March 1, 2019

Addendum Number 1
Invitation to Bid 19-02-207062
Portage Equipment Storage Building Construction

This addendum is being issued to provide information as follows:

D WALL SECTION
4 SCALE: 1/4" = 1'-0"

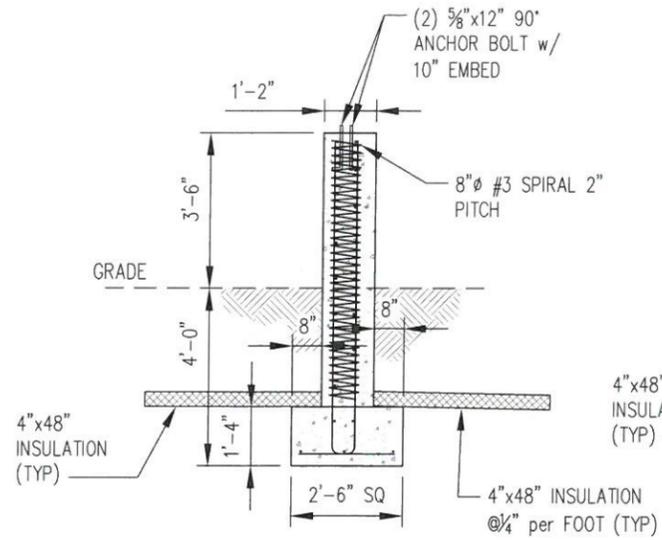
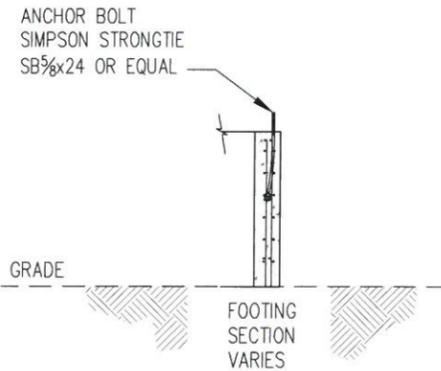
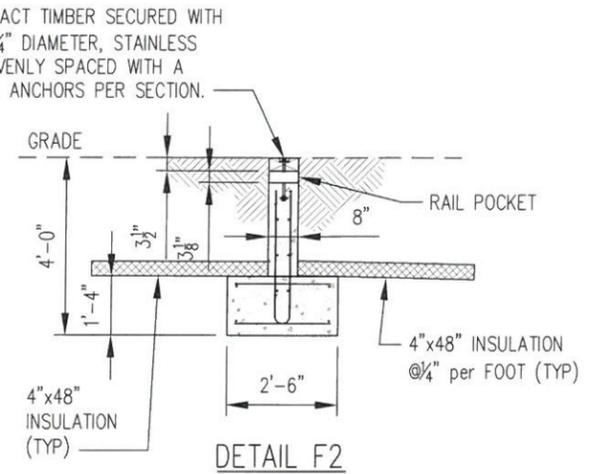
5. The foundation drawings do not call out the anchor sizes for the type D,E,F and G. I can get this information from the star building drawings if this is correct. *See attached ARRC drawing sheets 4 and 6 with notes referencing Star building callout letter.*

E TYPE E PILASTER
4 SCALE: 1/4" = 1'-0"

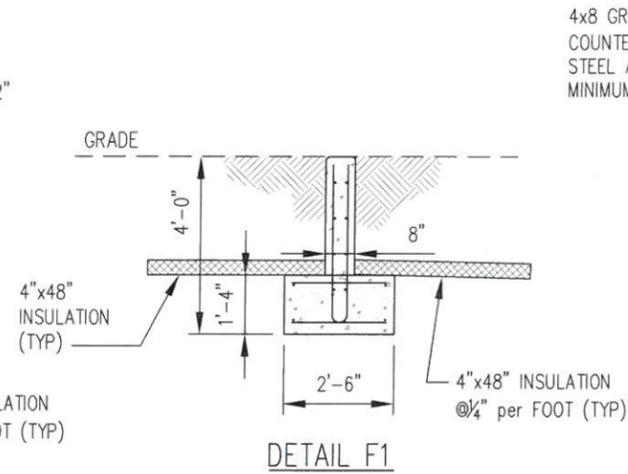
1. Detail E/4 page 4 Structural, Are type E pilasters anchor bolts to be galvanized? Any specific length of 90 degree return on bottoms, 2"? *Galvanizing is not required. A 2 inch return to the anchor bolt is adequate.*

A ANCHOR ROD ASSEMBLY A
6 SCALE: 1" = 1'-0"

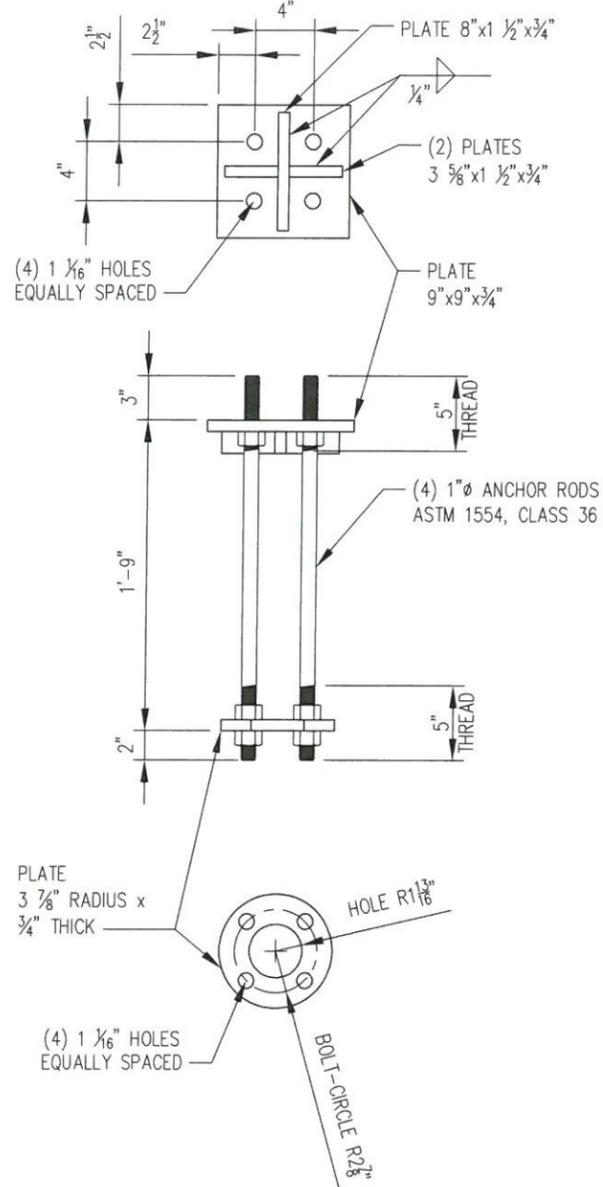
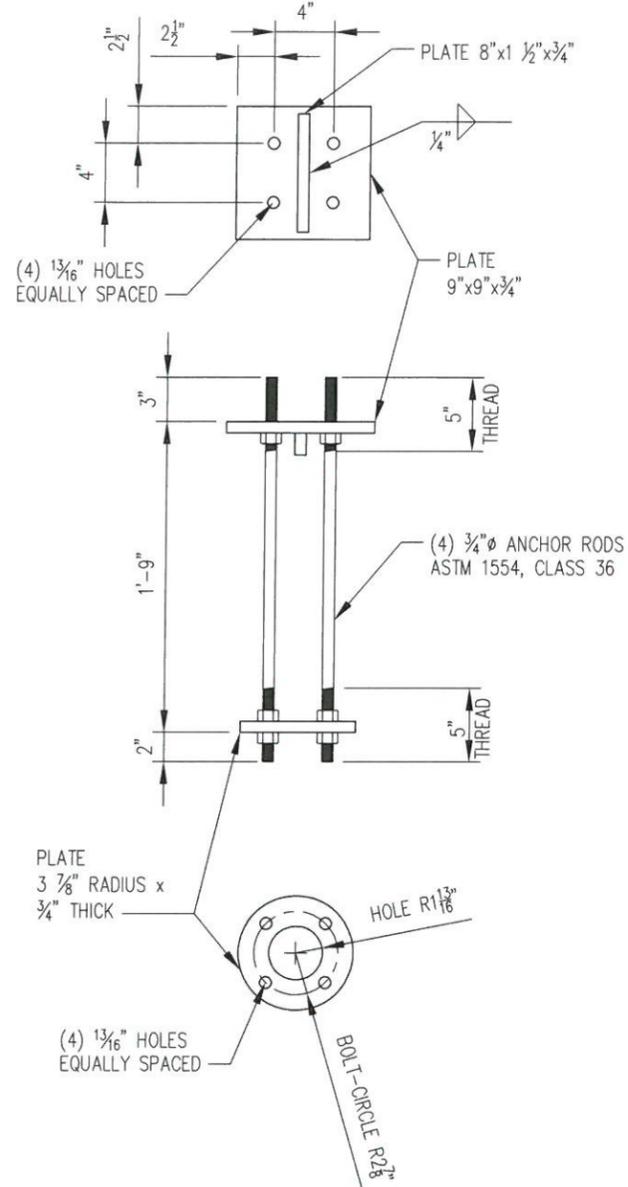
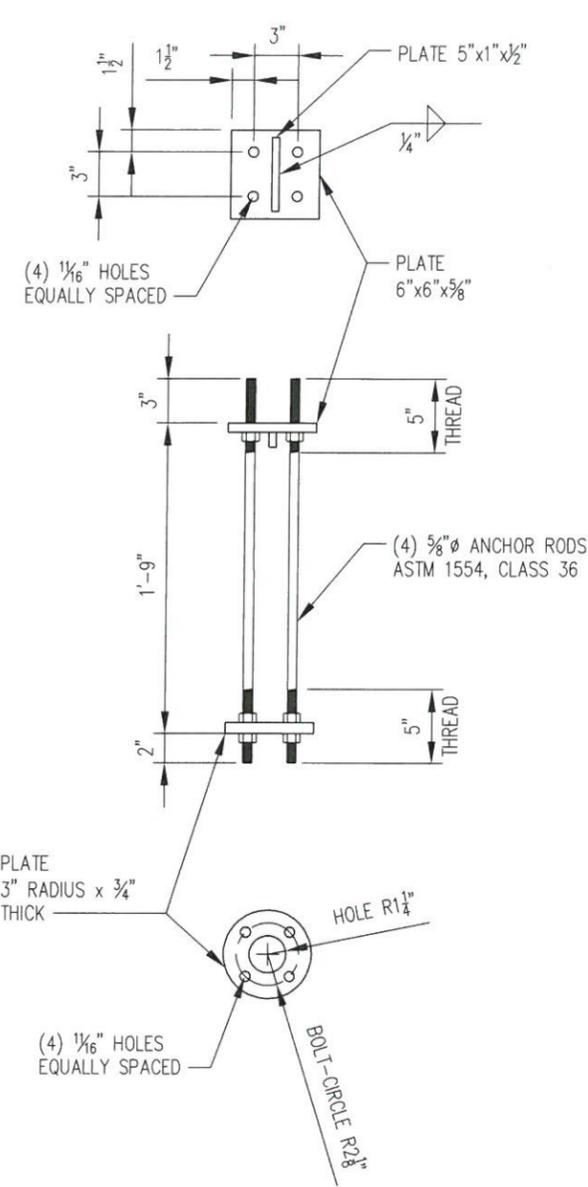
2. Details A,B,&C page 6 Structural, Do anchor rods need to be galvanized ? What about the embed plates associated with them. *No, mill finish.*
3. Are the anchor bolts provided by with the OFCI steel building? *No, anchor rods are contractor supplied.*

4. Please check anchor bolt plan drawing 6 of 8 which shows type A with a 1" bolt and type B with a 3/4" and type C with a 5/8". Reviewing the Star Building drawings anchor bolt plan the type A calls for 3/4" and the type B 1" and type C 3/4". Please verify which is correct. *The callout letter in the detail bubble for the anchor bolt detail drawings in ARRC drawings does not match the letter callout in the star building drawings.*
